## HORSHAM DISTRICT COUNCIL CONSULTATION

<b>TO:</b>	Horsham District Council – Planning Dept
<b>LOCATION:</b>	Land To The West of Shoreham Road Small Dole West Sussex
<b>DESCRIPTION:</b>	Outline planning application for up to 45 dwellings (including affordable homes) with all matters reserved apart from access.
<b>REFERENCE:</b>	DC/25/1019
<b>RECOMMENDATION:</b>	More Information / Modification No objection

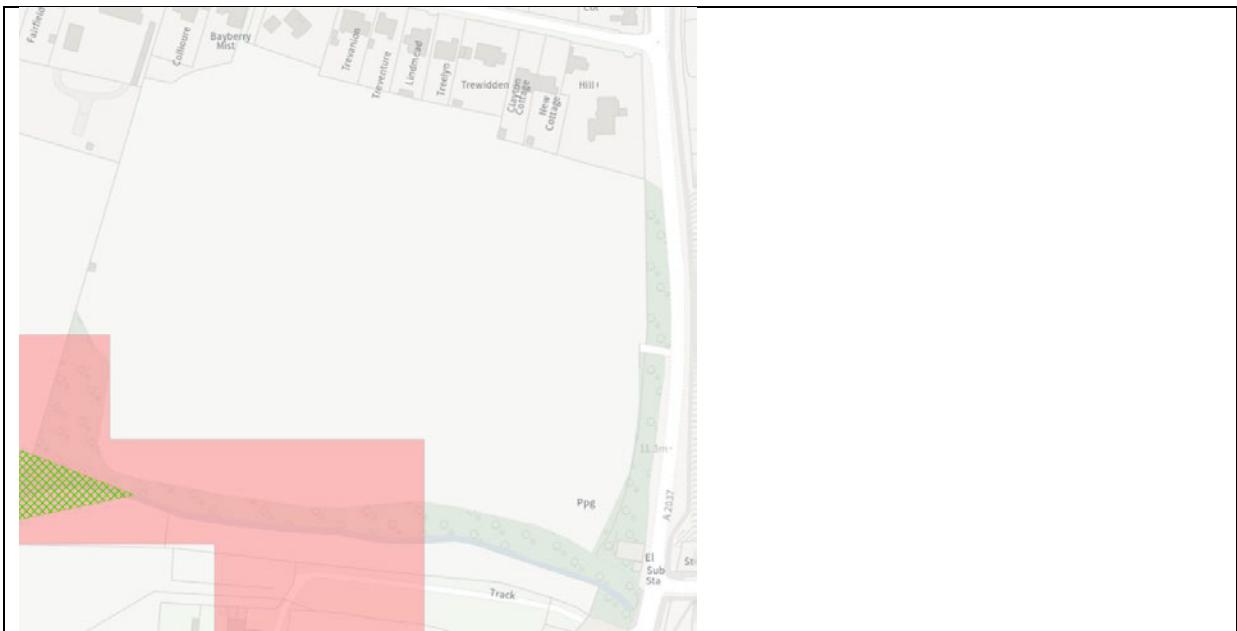
All habitats within the metric have been inputted as having a low strategic significance (area/compensation not in local strategy/no local strategy). However, please note that the south of the site comprising the priority woodland and watercourse fall within a very high potential site of the Wilder Horsham District Nature Recovery Network, and therefore as per HDC guidance, all habitats with a biodiversity value greater than zero within the metric should be assigned as having a medium strategic significance (location ecologically desirable but not in local strategy). It is therefore requested that the strategic significance for habitats in this area is amended.

**This has been amended. Concern resolved, with thanks.**
